Castroville Rd. 48-Inch Rehab Project- DR 144 Project
Solicitation Number: CO-00098-SM
Job No.: 14-4652

ADDENDUM 3
October 4, 2016

RESPONSES TO QUESTIONS

REVISION		10-04-16
No.	Revision	Drawn
DEVELOPER:		BUDGET PROJ. 33
SUBMITTED		
APPROVED		
MAP No.	126572, 128572, 130572	SHEET 21
SECT. No.	JOB No.	28
DR. PJ	CK. KC	SS NO. 14-4652

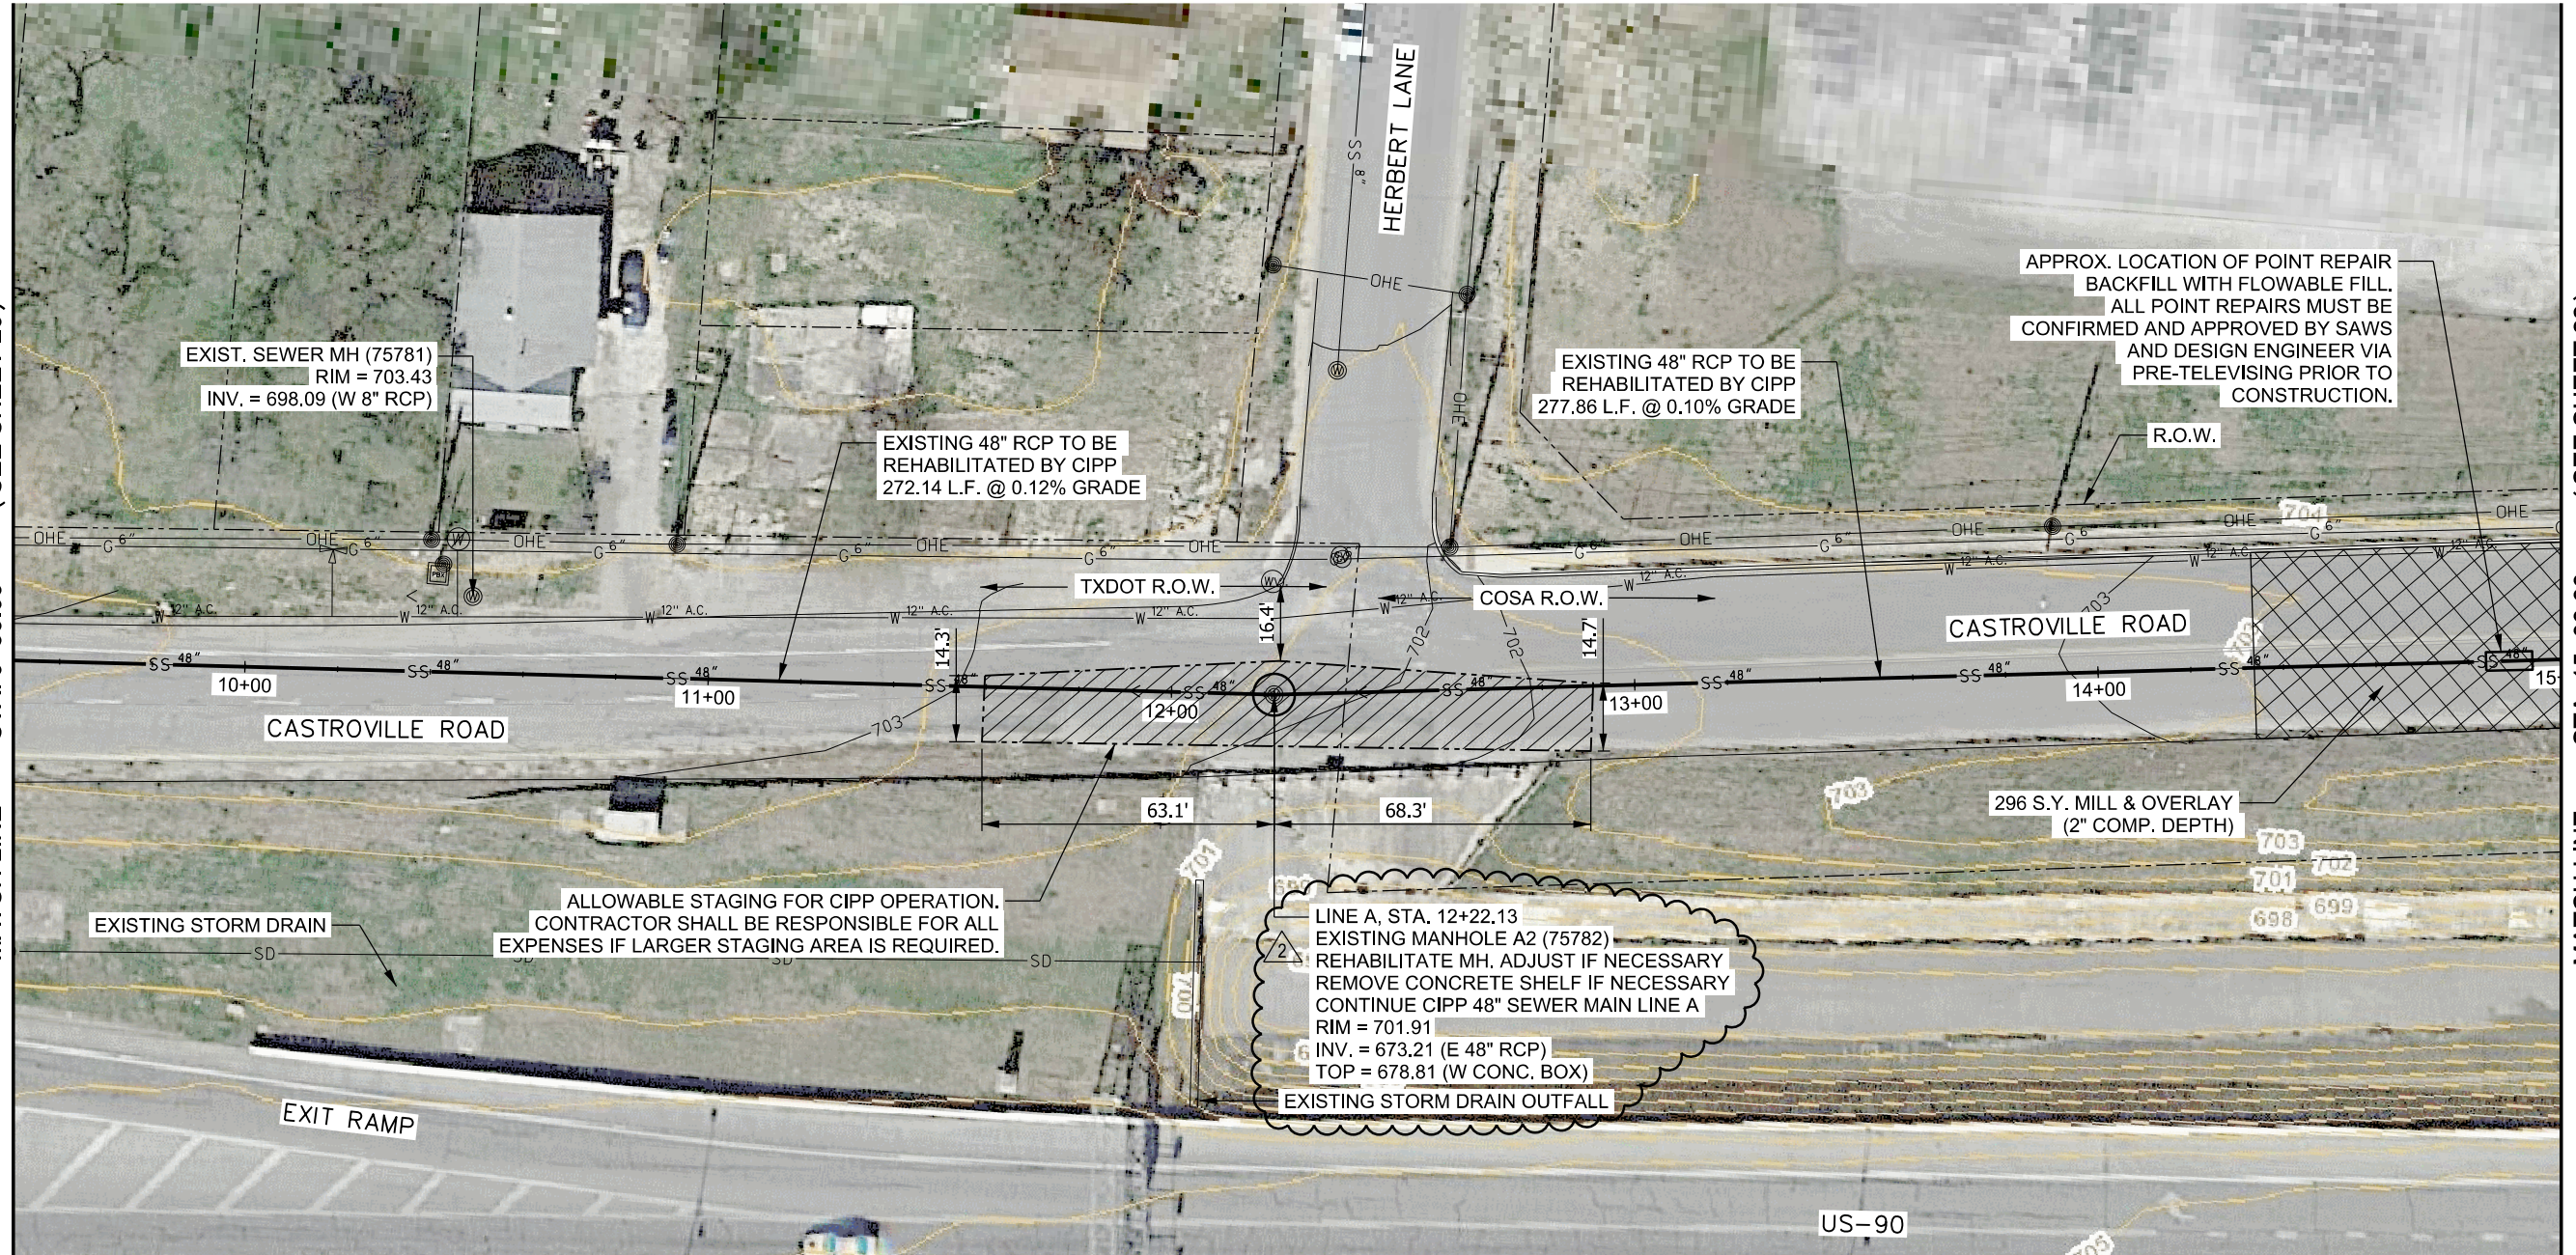
8. **Question: What concrete removal location is the bid item "Remove Miscellaneous Concrete" referring to?**

1. Sheet 3 has been revised to reflect addition of service tap connections.
2. Sheet 4 has been revised to reflect changes to the General Notes.
3. Sheet 21 has been revised to clarification location of Miscellaneous Concrete removal item.
4. Sheet 24 has been revised to correct call out labels related to televising existing 48" pipe and line size label conflict.

Response: If needed, there is a manhole that could be used as an entry pit that has a concrete shelf. This bid item is to account for any removal of that shelf needed to utilize that manhole. See also revisions to Sheet 21.

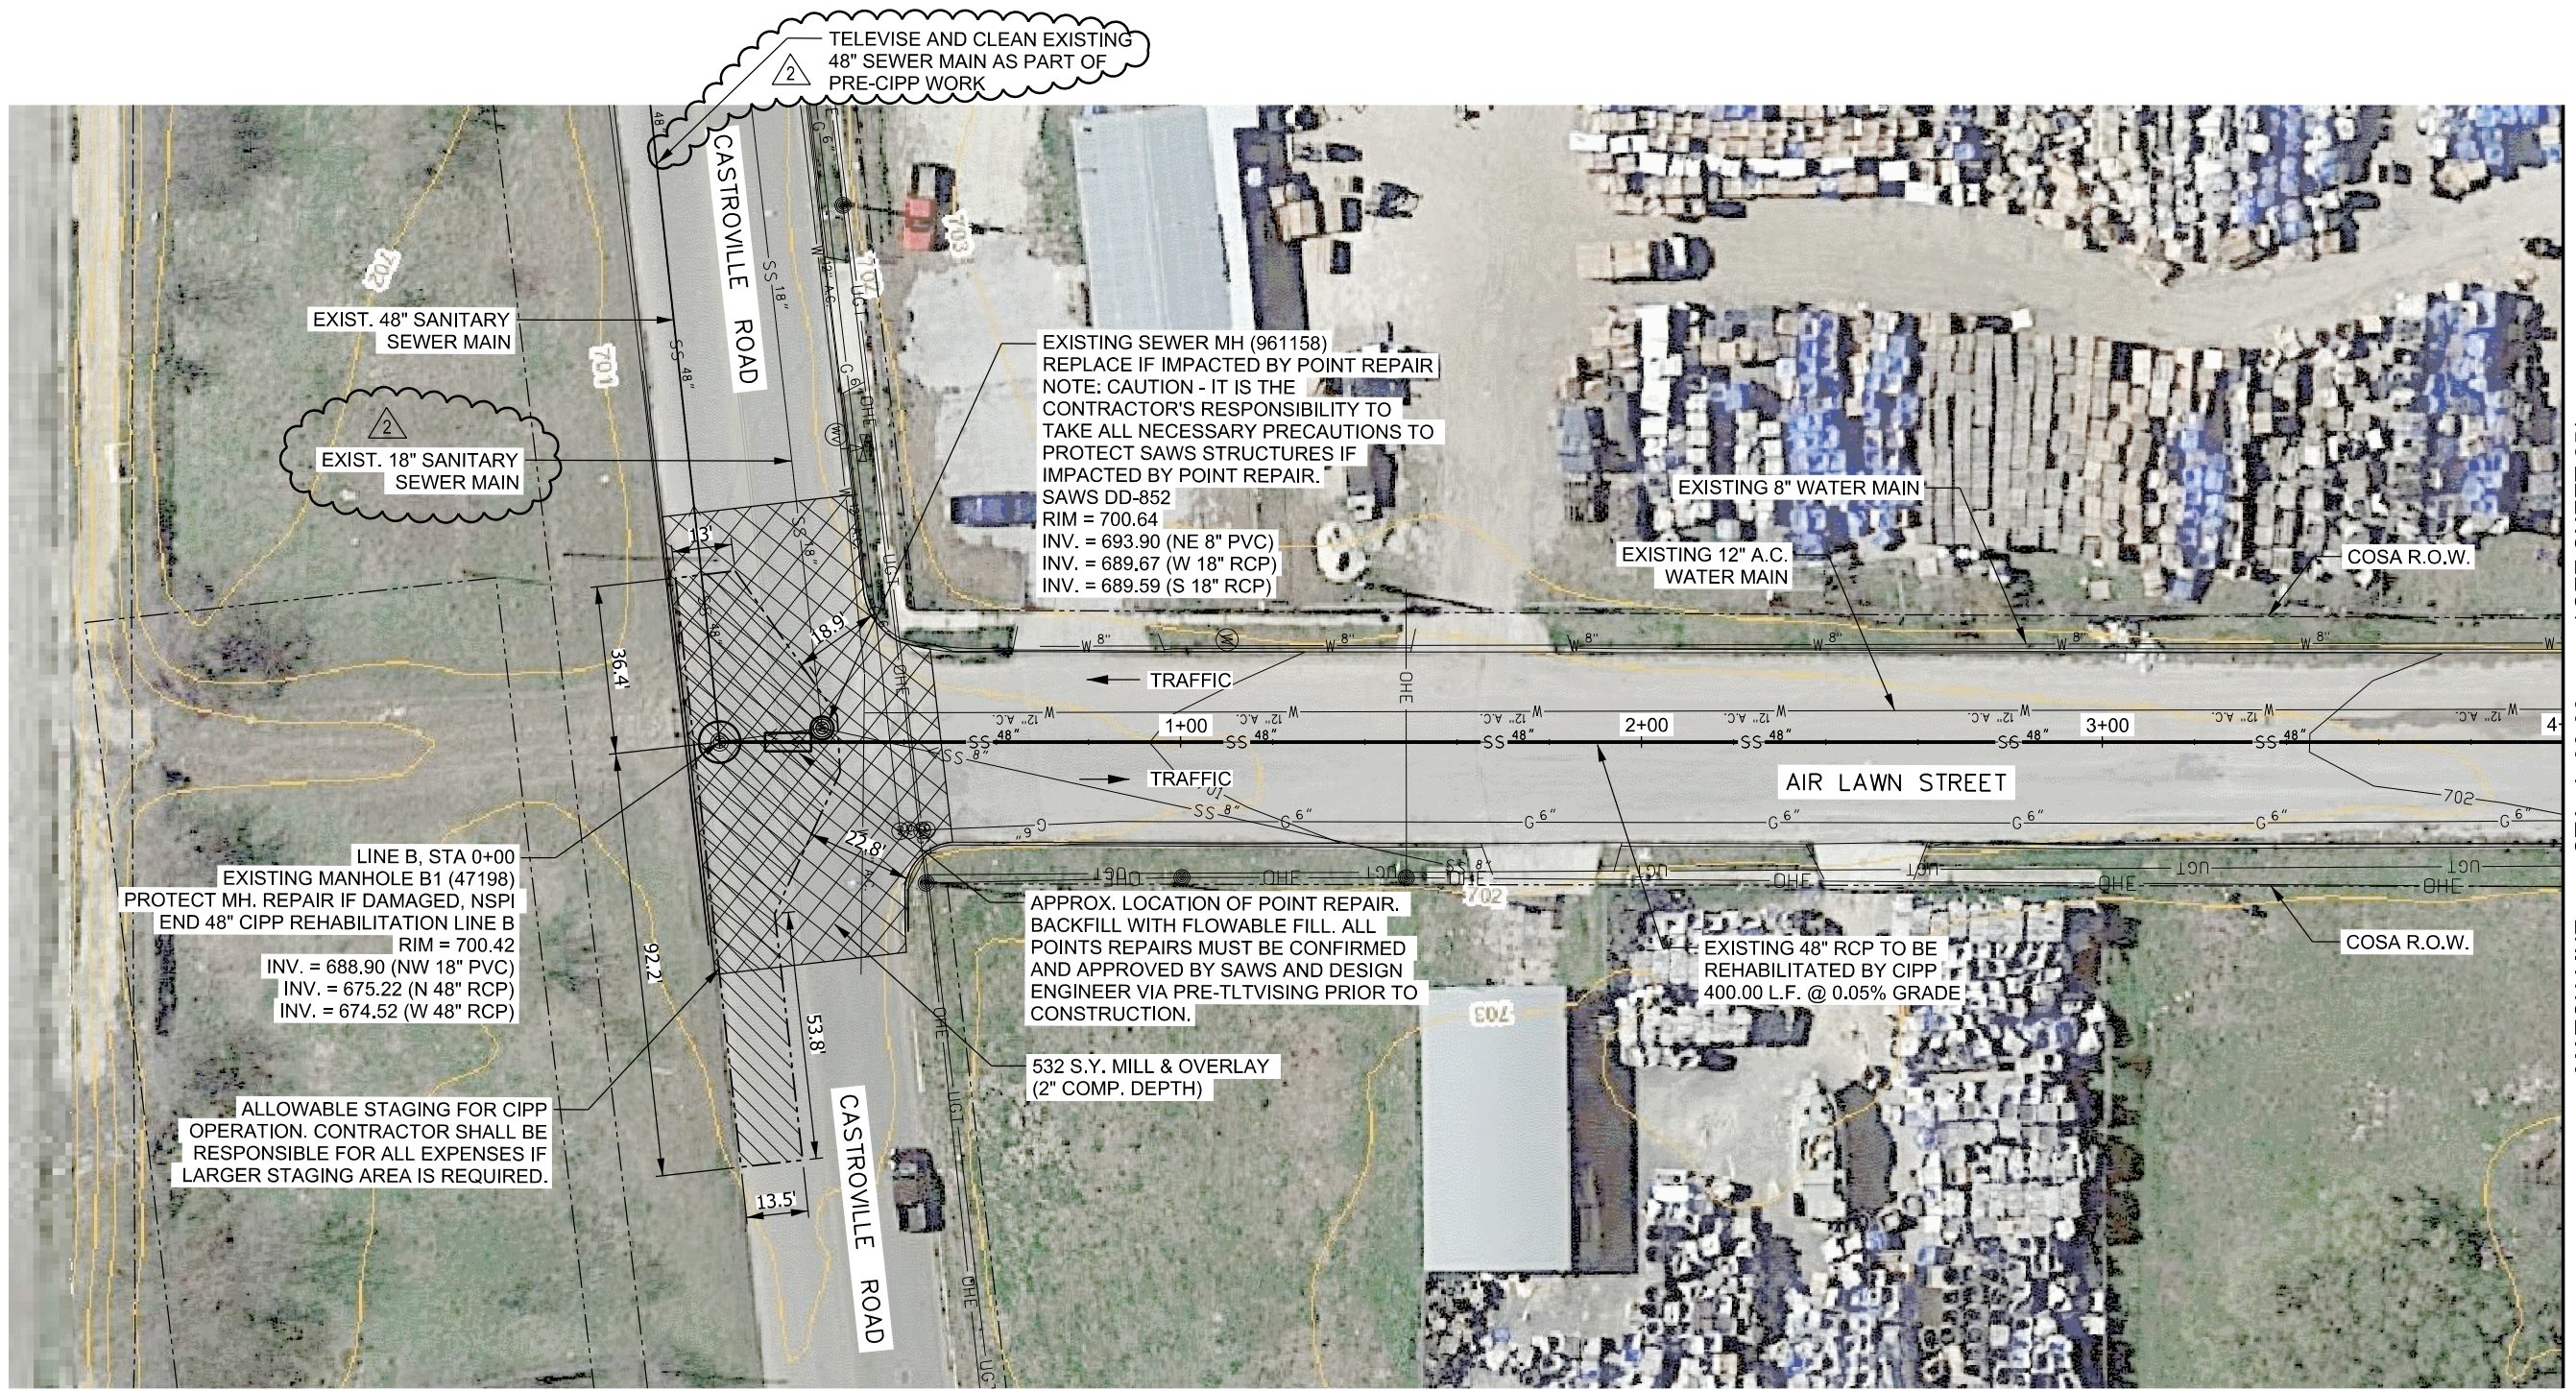
7. **Question: Why is the Pre-TV bid item 400 LF more than the Post-TV bid item?**

- 19. Question: Plan sheet 24 of 28. Please clarify or correct the Clean and TV designation of the 18” and 8”. It was observed that the pipe discharging into MH 47198 was approx. 12” dia. not 18**

Response: We would like to have the "gap" of pipe cleaned and televised (previously repaired). See also revisions to Sheet 24 callout.

Response: Sheet will be revised and included in this addenda.
